STAFF RECOMMENDATION

**1612 Forrest Avenue
November 18, 2015**

Application: New construction-detached accessory dwelling unit (DADU)
District: Lockeland Springs-East End Neighborhood Conservation Zoning Overlay
Council District: 06
Map and Parcel Number: 08310017900
Applicant: Aerial Development Group
Project Lead: Paul Hoffman, paul.hoffman@nashville.gov

Description of Project: The applicant proposes to build a detached accessory dwelling unit at the rear of the lot. The outbuilding requires a rear setback determination from the required ten feet (10') to five feet (5').

**1612 FOREST AVE
GARAGE
ELEVATIONS**

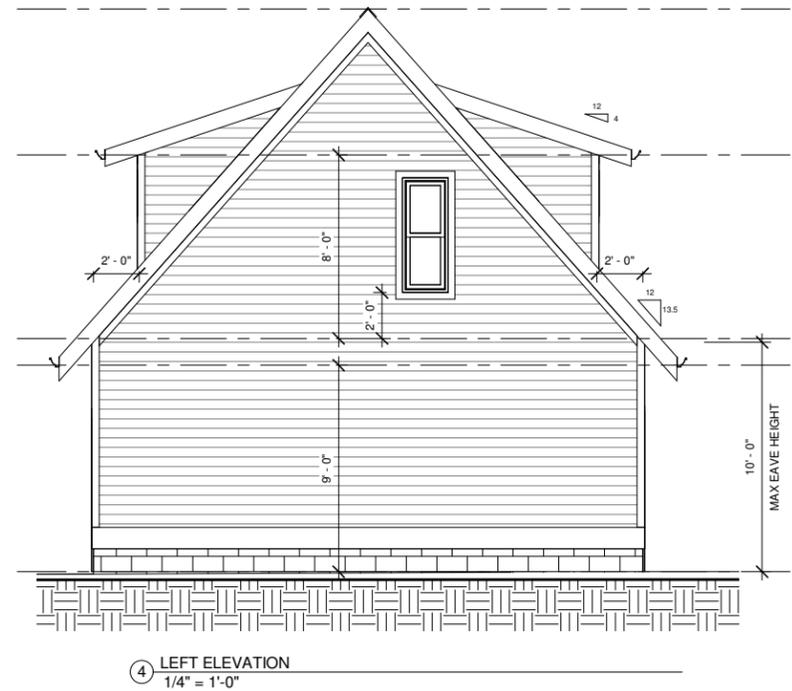
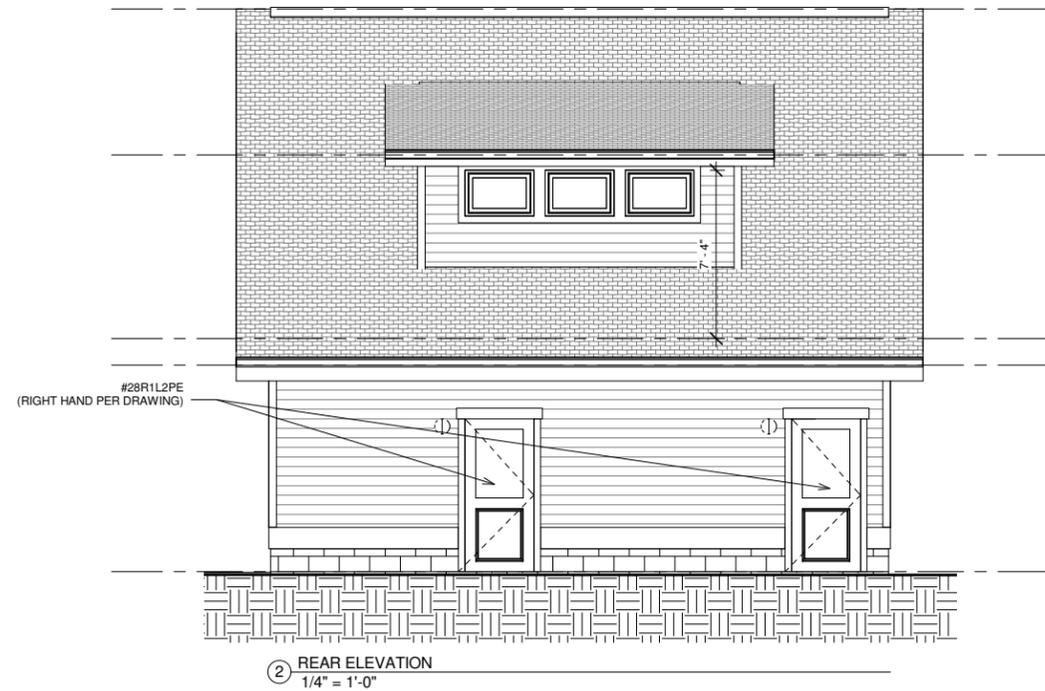
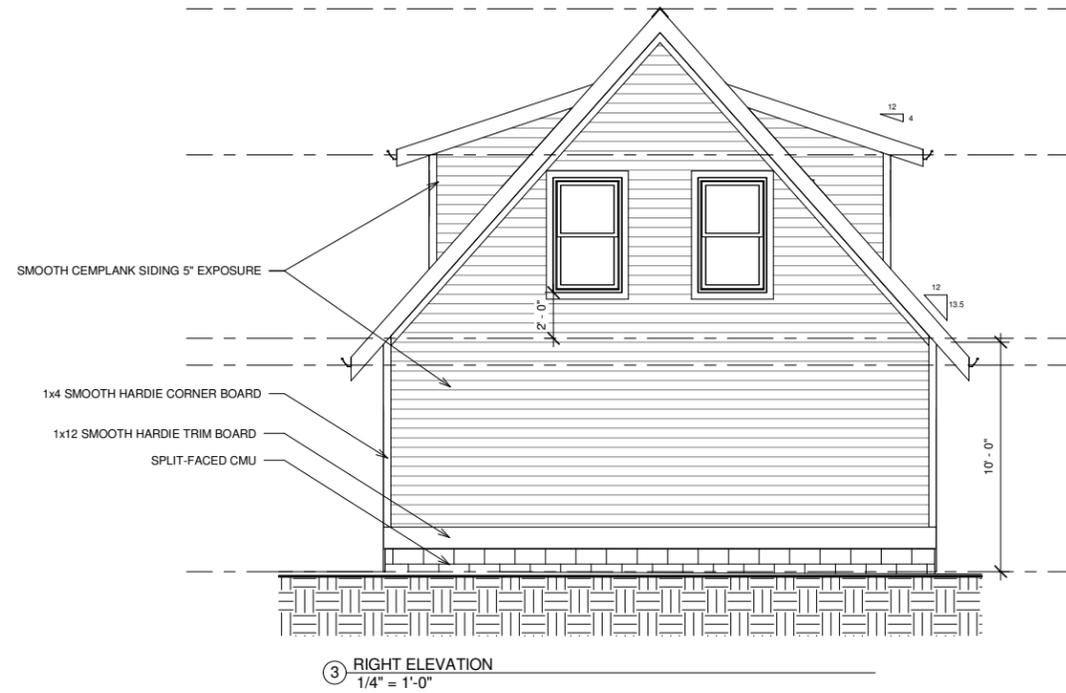
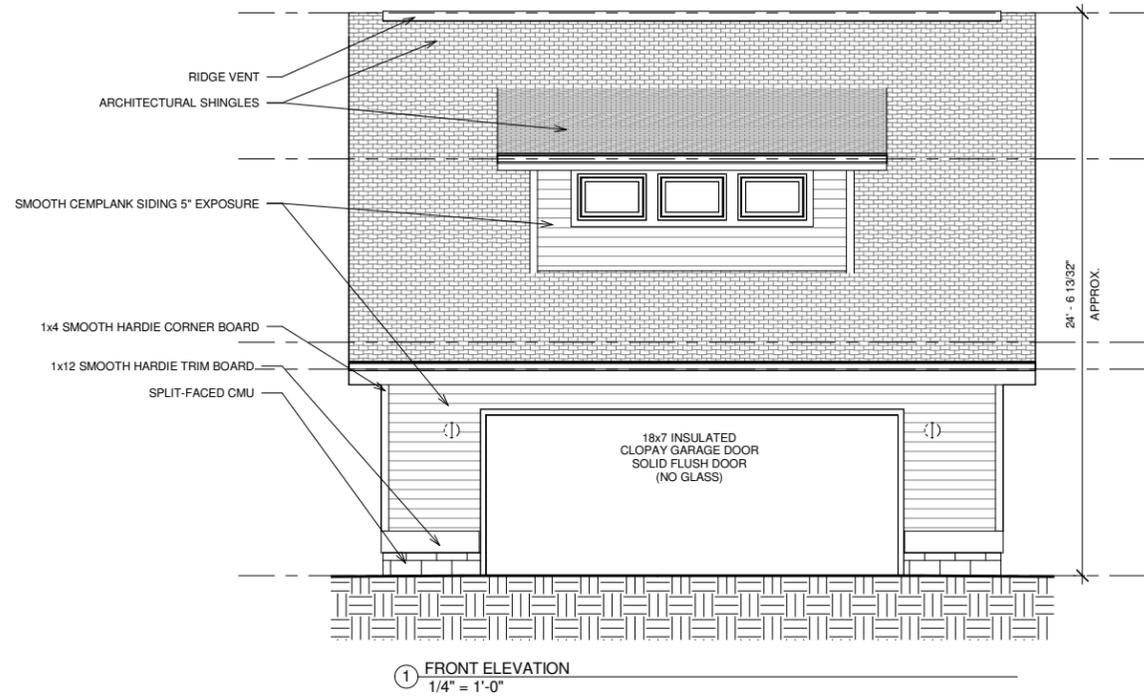
Height/Scale: The proposed outbuilding is one-and-a-half stories and has a footprint of six hundred and forty-eight square feet (648 sq. ft.). The ridge height is proposed at twenty-four feet, six inches (24'6"), with an eave height of ten feet (10'). GIS data indicates that the ridge height of the house is twenty-two feet (22'). The eave height is appropriate, but the ridge height is taller than that of the house. Staff recommends the ridge height be reduced to no more than twenty-two feet (22') in order to meet the requirements of the Code.

Recommendation Summary: Staff recommends approval of the detached accessory dwelling unit with a rear setback of five feet (5') with the following conditions:

1. The ridge height of the outbuilding must be less than the primary building;
2. Staff approve the windows, doors and garage doors;
